Access Compliance Report

Public Rights-of-Way

(Curb Ramps)

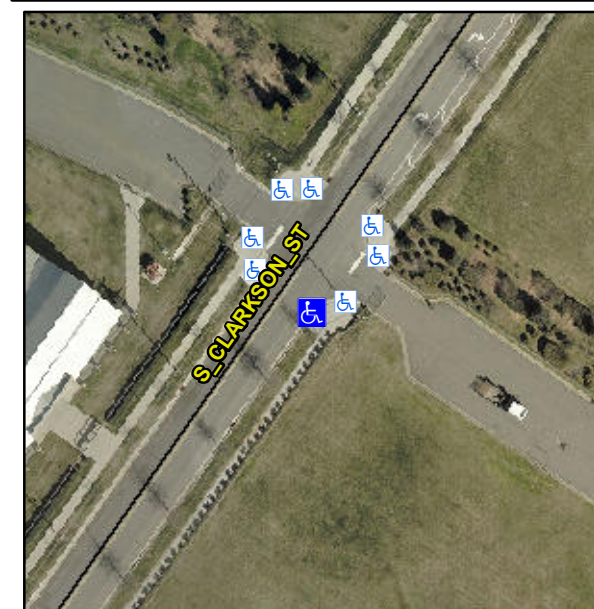
Not Found, R304.5.1, R304.5.3

Compliance	Description	Data	Compliance	Description	Data
N/A	Ramp Length (in)	96.0	Yes	Ramp Slope (%)	6.9
No	Ramp Width (in)	47.0	No	Ramp XSlope (%)	5.1
N/A	Flare Type LT	N/A	N/A	Flare Type RT	N/A
N/A	Flare Slope LT (%)	N/A	N/A	Flare Slope RT (%)	N/A
N/A	Flare Traversable LT?	N/A	N/A	Flare Traversable RT?	N/A
N/A	Landing Length (in)	N/A	N/A	DWS Provided?	N/A
N/A	Landing Width (in)	N/A	N/A	DWS Contrast?	N/A
N/A	Landing Slope (%)	N/A	N/A	DWS Length (in)	N/A
N/A	Landing X Slope (%)	N/A	N/A	DWS Full Width?	N/A
N/A	Landing Curb? (Y/N)	N/A	N/A	DWS Offset (in)	N/A
N/A	Shared Landing?	N/A			
N/A	Gutter Ponding?	N/A	N/A	Gutter Slope (%)	N/A
N/A	Gutter Lip Ht (in)	N/A	N/A	Gutter X Slope (%)	N/A
N/A	Painted X Walk1?	No	N/A	Painted X Walk2?	N/A
	X Walk 1 Direction	To NW		X Walk 2 Direction	N/A
N/A	X Walk 1 Width (in)	N/A	N/A	X Walk 2 Width (in)	N/A
	X Walk 1 Slope (%)	3.2		X Walk 2 Slope (%)	N/A
	X Walk 1 X Slope (%)	1.0		X Walk 2 X Slope (%)	N/A

Remove & Replace Entire Ramp.
